Model change for Pascal pump

MODEL		DWG.NO.
HPX / X series	Comparison figure (Pascal pump)	4HGYA29400

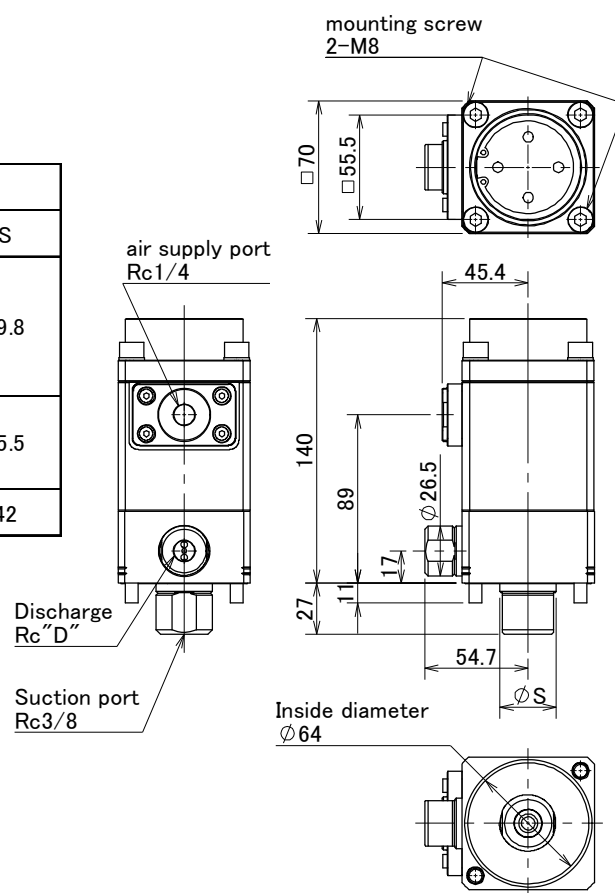
There are a few changes. Refer to the sketch shown below.
(Muffler height, mounting screw on air supply port flange)

X series X series are mounting interchangeable with model HPX and the boosting ratio remains same.

model	boosting ratio	Discharge Flow (note)	dimension	
			D	S
X6306	97	0.8 L/min	Rc1/4	29.8
X6308	58	1.3 L/min		
X6310	37	2.0 L/min		
X6312	24	2.8 L/min	Rc3/8	35.5
X6316	15	3.6 L/min		
X6320	9.2	4.3 L/min
